ADDENDUM #2:

Sheet 632

No.	Revisions	By	Date
CITY OF WICHITA			
ELECTRICAL			
GENERAL NOTES & LEGEND			
SEDGWICK COUNTY			
Professional Engineering Consultants, P.A. 303 S. TOPEKA • WICHITA, KANSAS 67202 316-262-2691 • FAX 316-262-3003			
Designed by	SMS	Checked by	SMS
Drawn by	WAN	Date	APRIL, 2002
		Job No.	97362

DUCTBANK DETAIL
NO SCALE

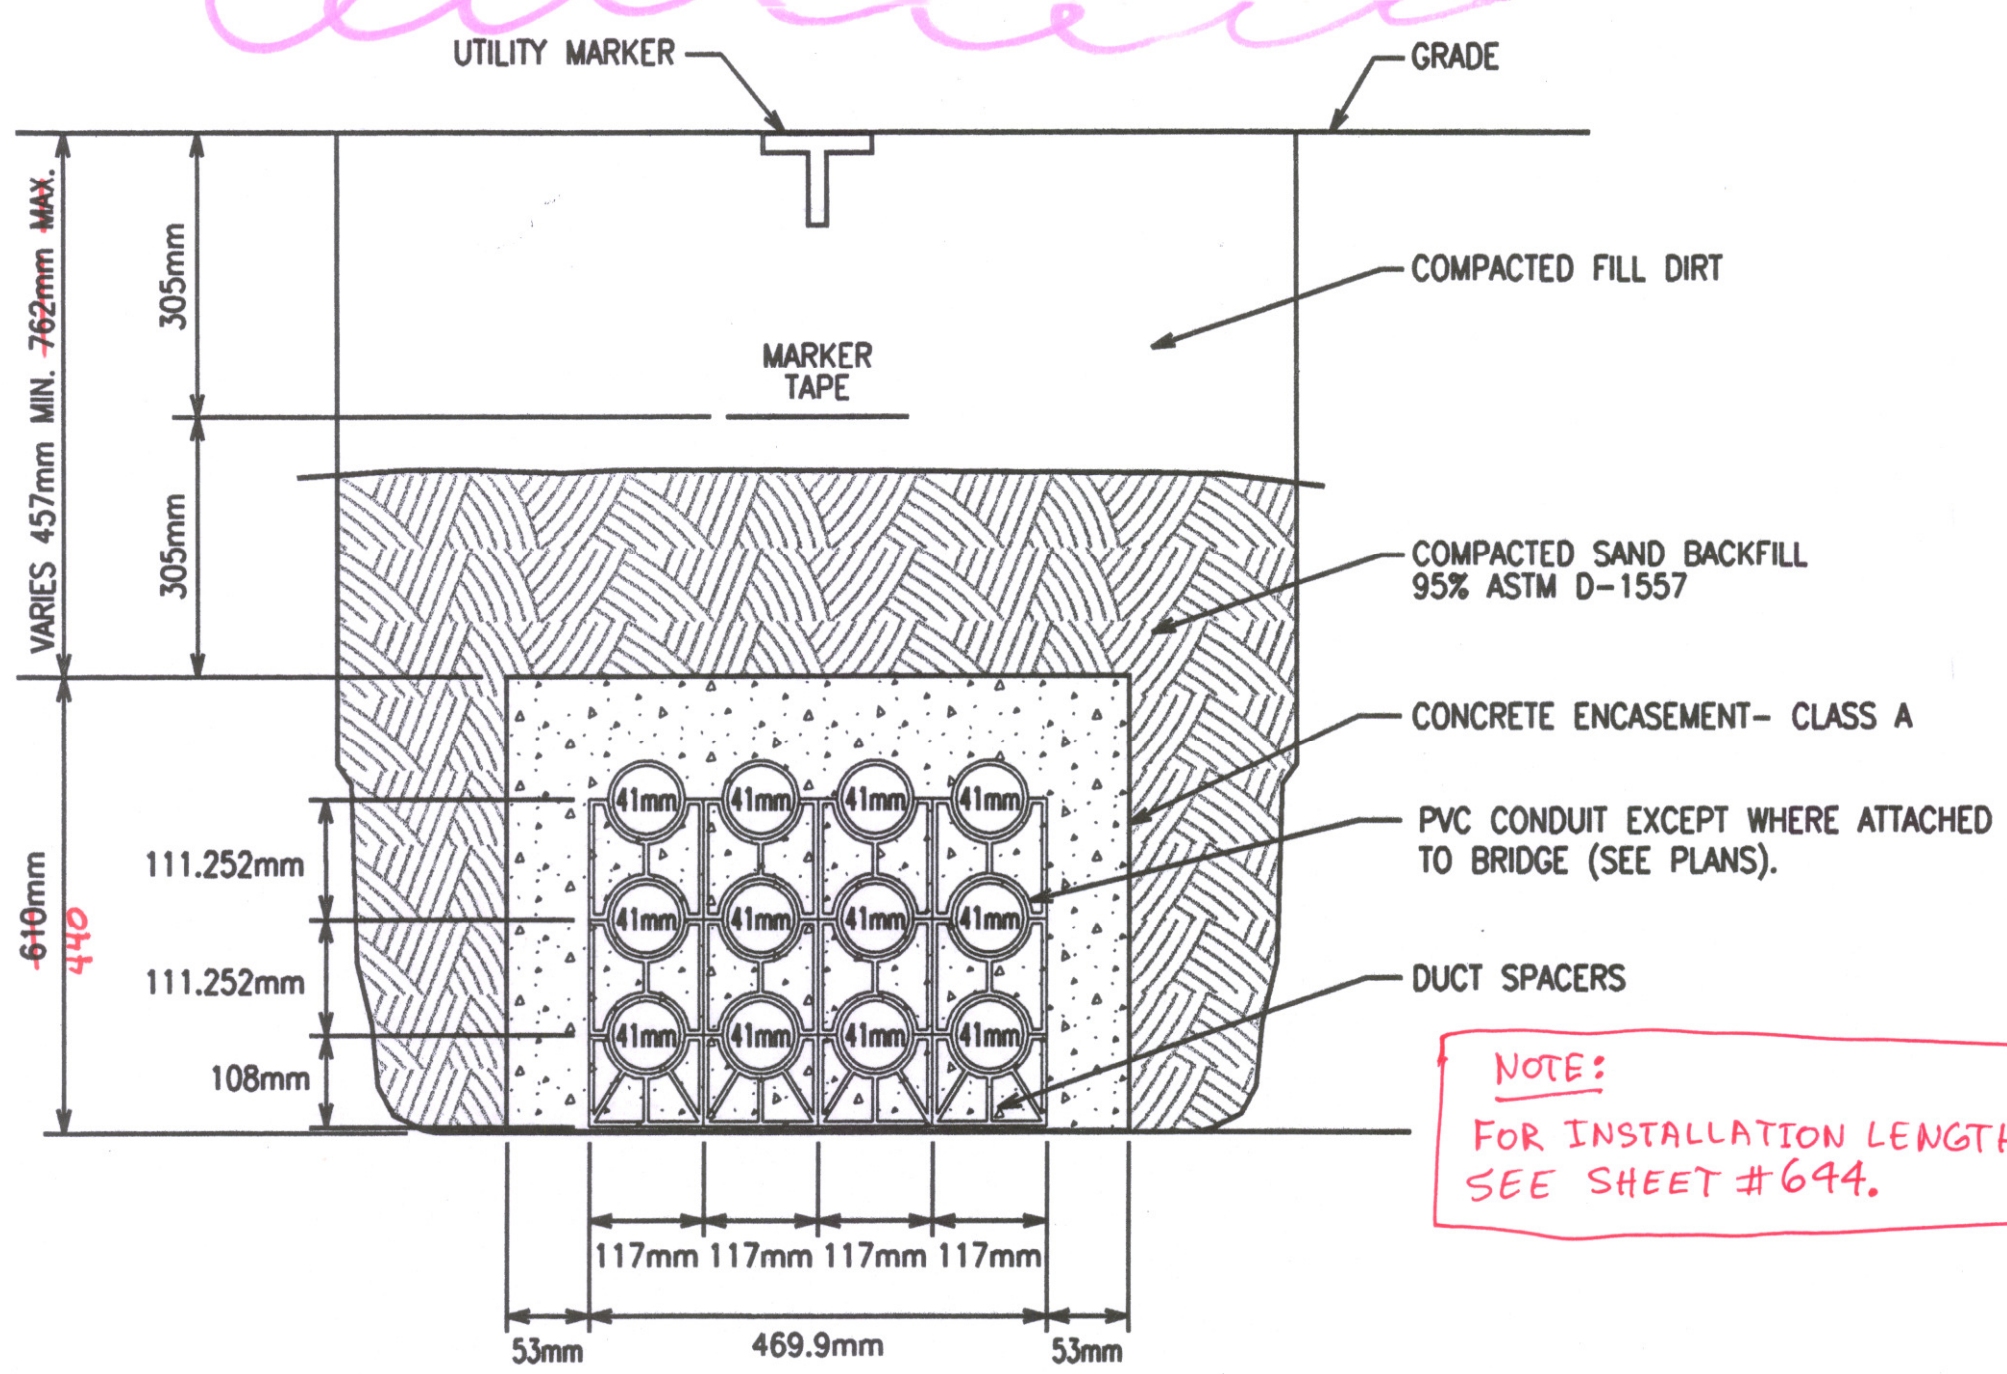
1. Ductbank Detail: Change the overall height of the concrete encasement from 610 mm to 440 mm. It is acceptable to use excavated trench walls to form the duct bank where soil conditions permit rather than the formed ductbank shown. Delete the maximum depth of 762 mm from the top of the ductbank to the top of the trench. Excavatable flowable fill will only be required under pavement where the depth of backfill from the top of the ductbank to the top of the subgrade exceeds 600 mm.
